SHEET TITLE: FLOOR PLAN - POWER	DATE: 08-18-17	PROJECT NO.: EGP#17148.00
SHEET NO. L1.0

COMCAST
MONUMENT
SERVICE UPGRADE
20021 BEACON LITE ROAD
MONUMENT, COLORADO

Markup Summary

1 LANDSCAPE PLAN
L1.0 SCALE: 1" = 10'-0"

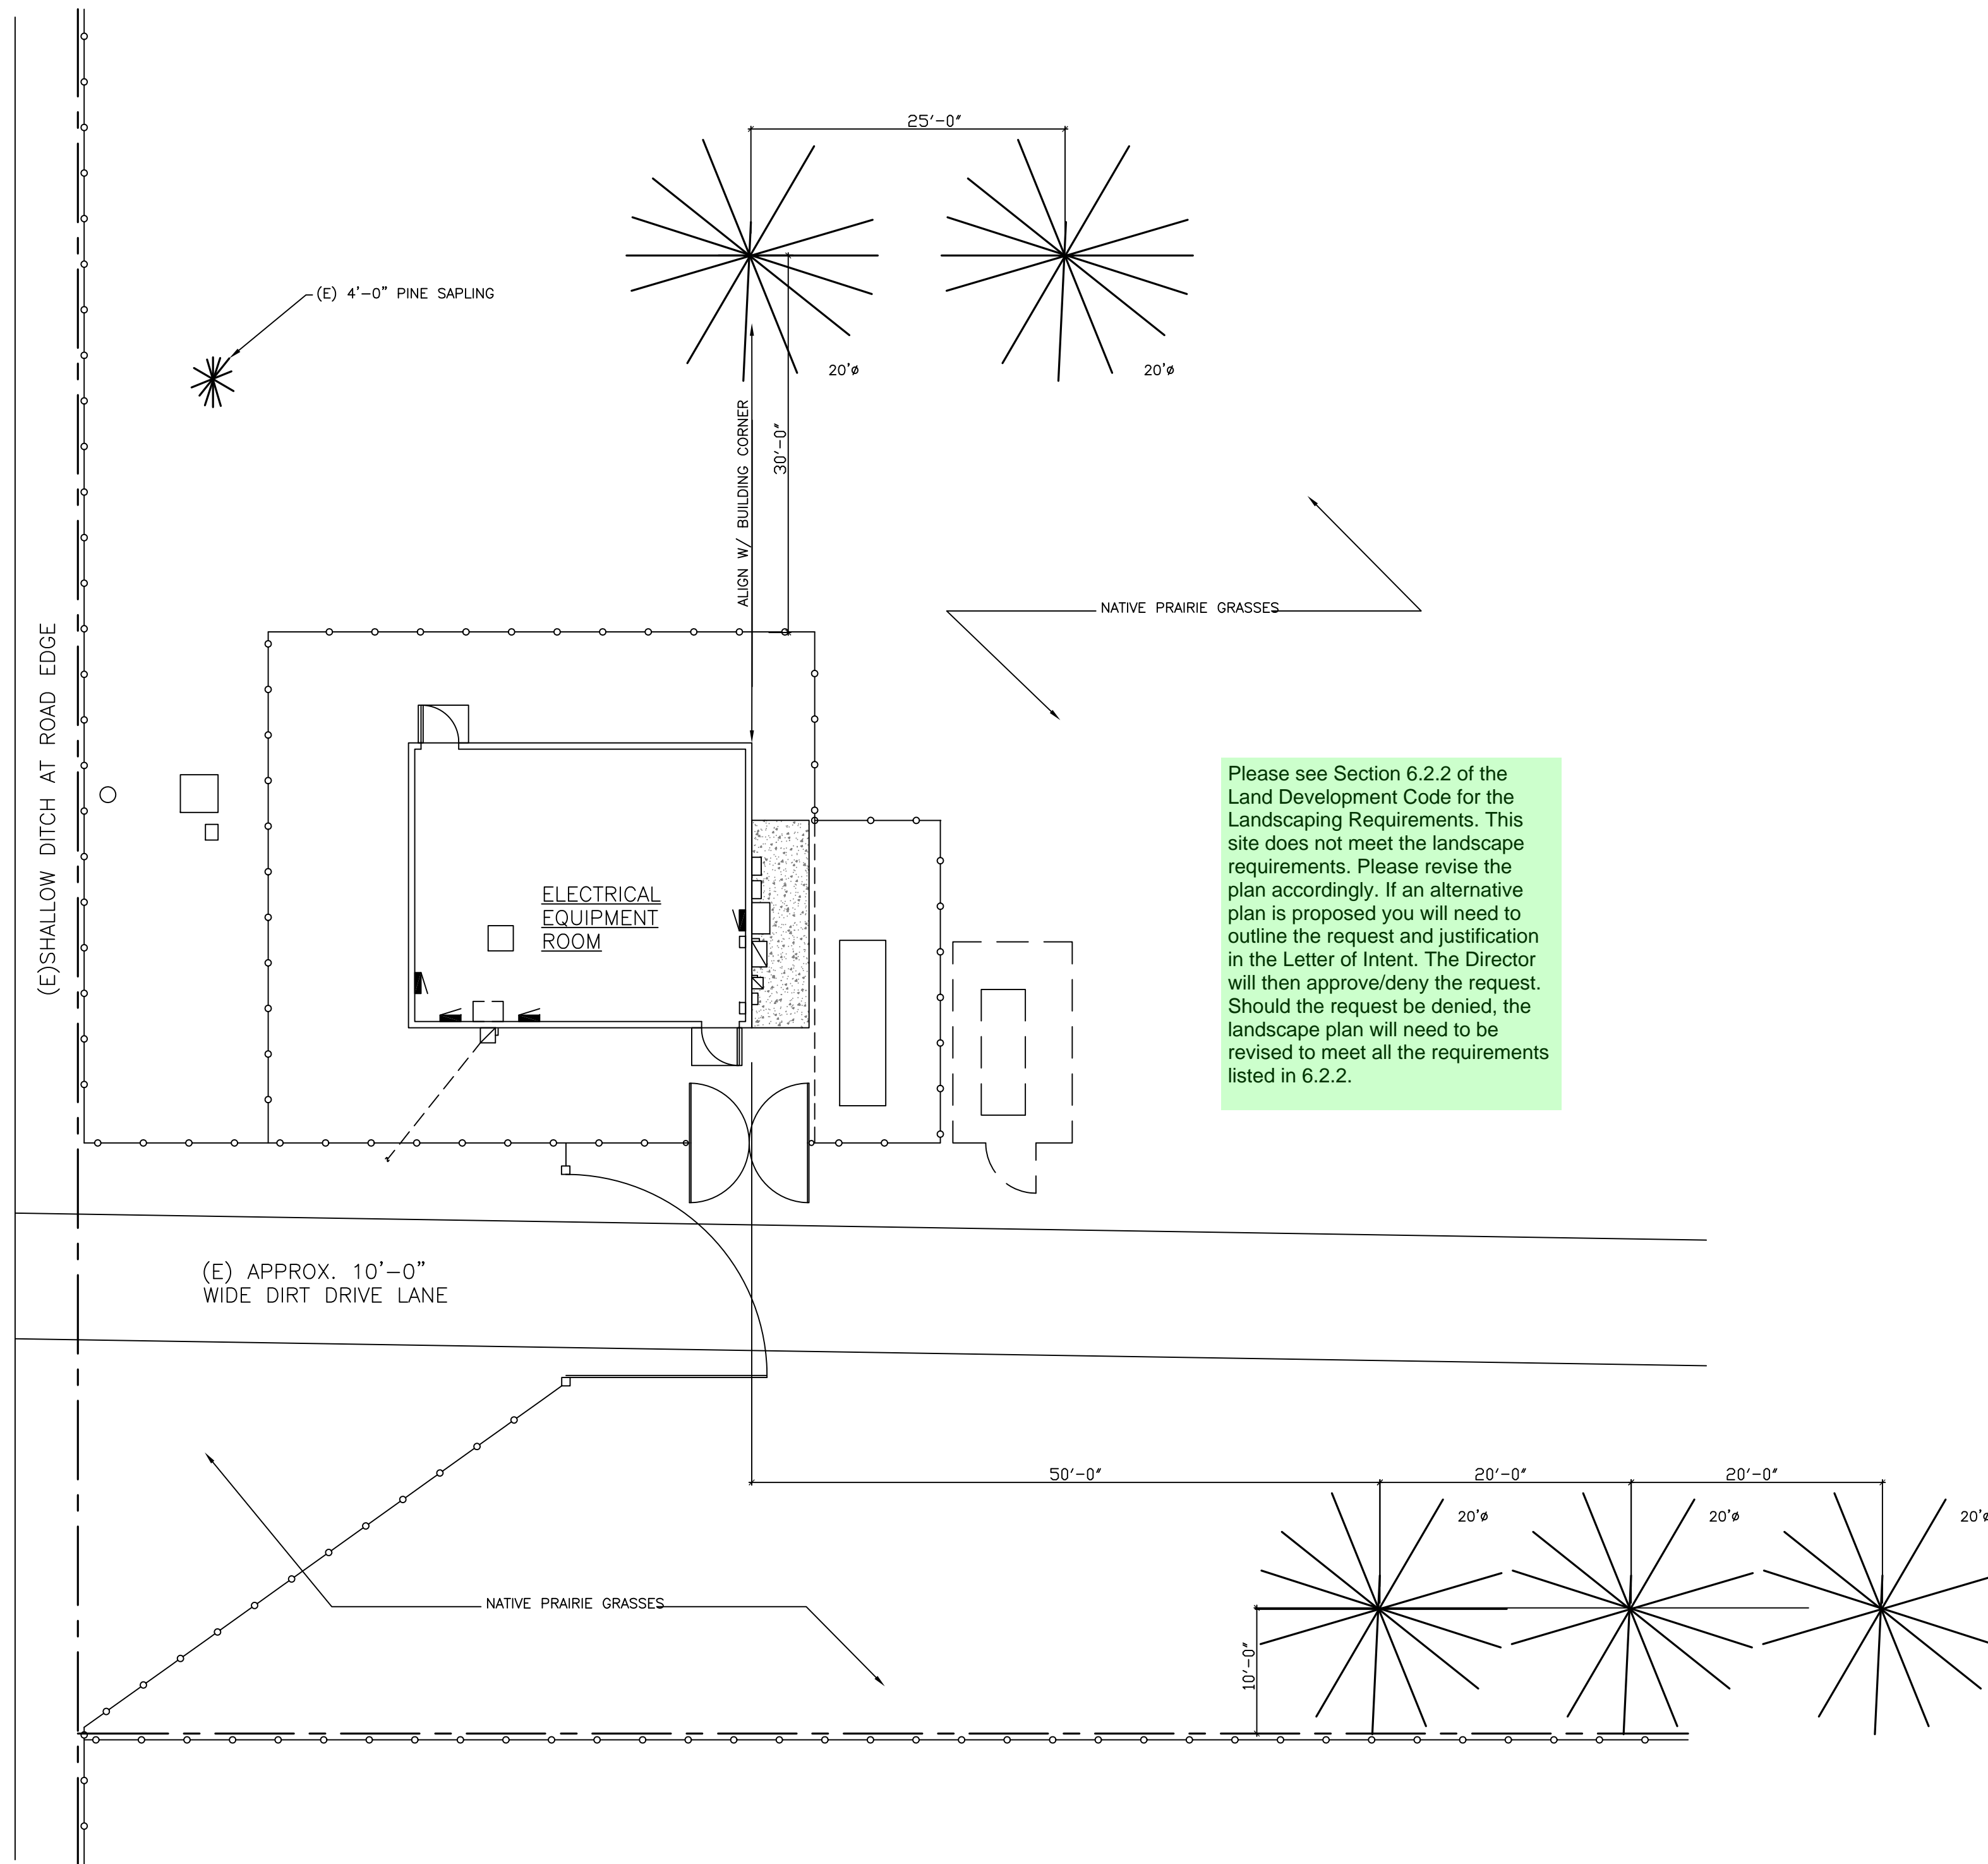
Please see Section 6.2.2 of the Land Development Code for the Landscaping Requirements. This site does not meet the landscape requirements. Please revise the plan accordingly. If an alternative plan is proposed you will need to outline the request and justification in the Letter of Intent. The Director will then approve/deny the request. Should the request be denied, the landscape plan will need to be revised to meet all the requirements listed in 6.2.2.

Please see Section 6.2.2 of the Land Development Code for the Landscaping Requirements. This site does not meet the landscape requirements. Please revise the plan accordingly. If an alternative plan is proposed you will need to outline the request and justification in the Letter of Intent. The Director will then approve/deny the request. Should the request be denied, the landscape plan will need to be revised to meet all the requirements listed in 6.2.2.
